## PROPOSED CHANGE RTS-66B TO DAEC TECHNICAL SPECIFICATIONS

Appendix A of the Technical Specifications for the DAEC (DPR-49) provides as follows:

FIGURE 3.6-1

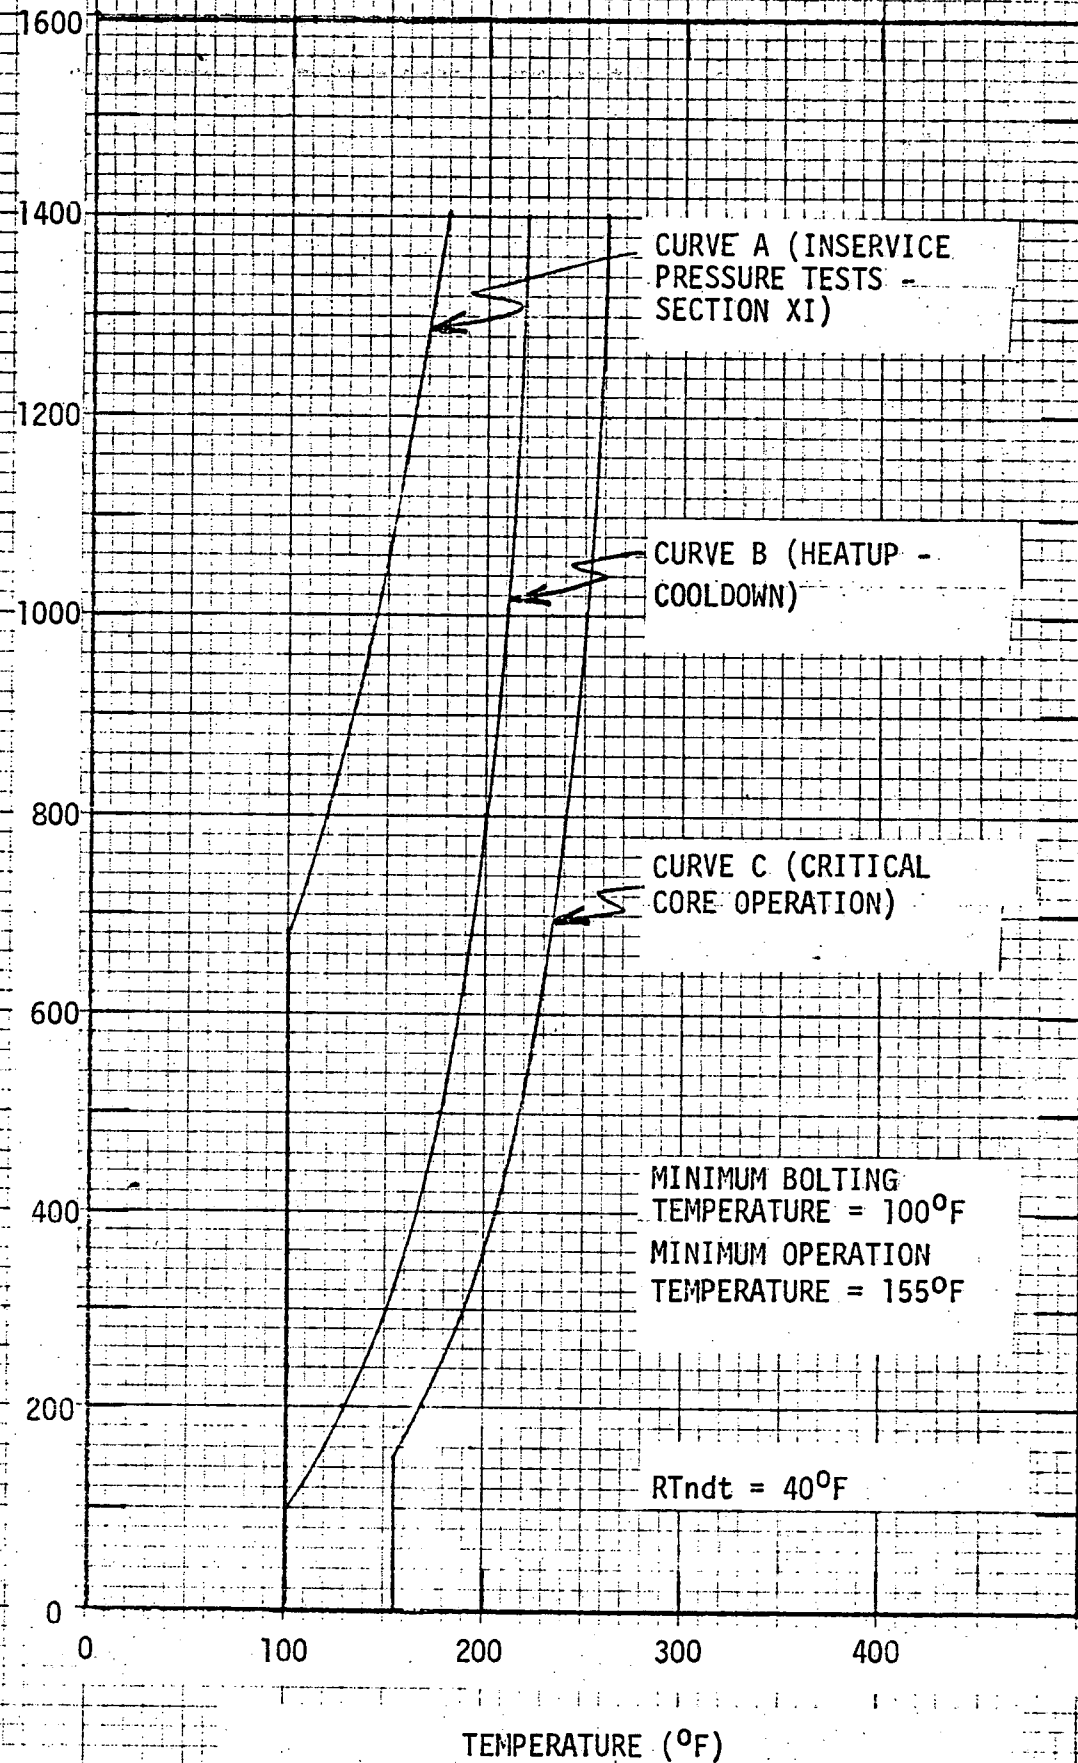
Delete the present Specification 3.6.A and 4.6.A (limiting Conditions for Operations, Surveillance Requirement and Bases for Thermal and Pressurization Limitations) including Figure 3.6-1 and Table 3.6-1.

Replace with the attached Specifications 3.6.A and 4.6.A, including Figure 3.6-1.

This revised change is being submitted to conform the DAEC Technical Specifications to the requirements of 10CFR50 Appendix G. Our original submittal was forwarded May 21, 1976 (RTS-66A). Additional information was requested in the NRC letter dated February 9, 1977 from Mr. G. Lear to Mr. D. Arnold. Our response dated October 12, 1977 provided the requested information, but did not forward revised proposed Technical Specifications. Submittal of a Technical Specification revision was postponed pending resolution of the applicability to a BWR plant for the requirement specified in 10CFR50, Appendix G, paragraph IV.A.2.C concerning the criticality limit based on the inservice hydrostatic test minimum temperature.

The proposed Technical Specification changes are based on analysis performed by General Electric (NEDO-21778-A, 77 NED238, Class I, December 1978, "Transient Pressure Rises Affecting Fracture Toughness Requirements for Boiling Water Reactor) and the information provided in our October 12, 1977 response. The objective of the criticality limit based on the temperature required for an inservice hydrostatic test plus a 40°F specified temperature margin is to ensure acceptable limits of stress and thermal shock are maintained during anticipated operational occurrences in the control of reactivity. The report concludes that the maximum predicted effect for a BWR during anticipated operational occurrences in the control of reactivity is a pressure increase of less than 25 pounds per square inch. Since this pressure increase is very small, the requirements for minimum temperature criticality limits based on the inservice hydrostatic test minimum temperature should be deleted for BWR operations. Conservatism will be maintained

for BWR operation by the retention of the required 40° F criticality margin.

Results of these analyses will be used to adjust Figure 3.6-1 as appropriate.
